Access Compliance Report

Public Rights-of-Way

(Curb Ramps)

Intersection ID: N/A	Main Street: LANGWELL_LN	Cross Street: INVERNESS_BAY_RD	Location: NE
ADA ID: 1E18D47C1B3F	Ramp Type: Perp	Initial Pass/Fail: Fail	Overall Compliance: No
Codes/Mitigation Info/Possible Solution		Field Measurements/Component Compliance	
Severity Score: 46.25

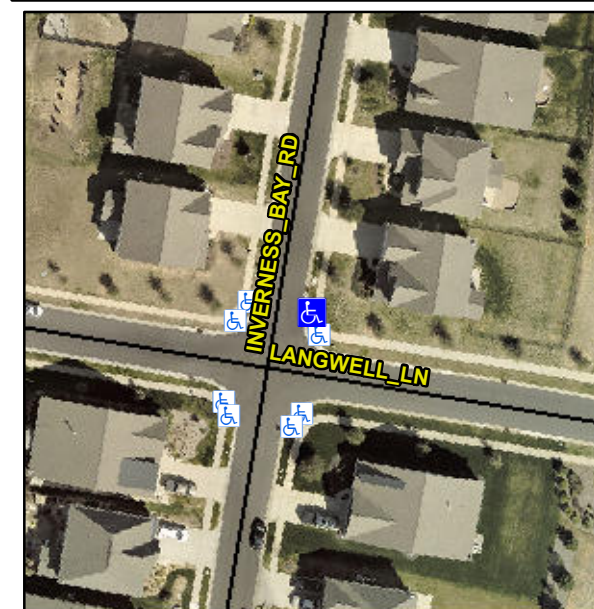
Not Found, R304.5.1, R304.2.2, R304.5.3

Compliance	Description	Data	Compliance	Description	Data
N/A	Ramp Length (in)	47.0	No	Ramp Slope (%)	9.7
No	Ramp Width (in)	47.0	No	Ramp XSlope (%)	7.0
N/A	Flare Type LT	N/A	N/A	Flare Type RT	N/A
N/A	Flare Slope LT (%)	N/A	N/A	Flare Slope RT (%)	N/A
N/A	Flare Traversable LT?	N/A	N/A	Flare Traversable RT?	N/A
N/A	Landing Length (in)	N/A	N/A	DWS Provided?	N/A
N/A	Landing Width (in)	N/A	N/A	DWS Contrast?	N/A
N/A	Landing Slope (%)	N/A	N/A	DWS Length (in)	N/A
N/A	Landing X Slope (%)	N/A	N/A	DWS Full Width?	N/A
N/A	Landing Curb? (Y/N)	N/A	N/A	DWS Offset (in)	N/A
N/A	Shared Landing?	N/A			
N/A	Gutter Ponding?	N/A	N/A	Gutter Slope (%)	N/A
N/A	Gutter Lip Ht (in)	1.0	N/A	Gutter X Slope (%)	N/A
N/A	Painted X Walk1?	No	N/A	Painted X Walk2?	N/A
	X Walk 1 Direction	To NW		X Walk 2 Direction	N/A
N/A	X Walk 1 Width (in)	N/A	N/A	X Walk 2 Width (in)	N/A
	X Walk 1 Slope (%)	1.9		X Walk 2 Slope (%)	N/A
	X Walk 1 X Slope (%)	5.3		X Walk 2 X Slope (%)	N/A

Remove & Replace Entire Ramp.
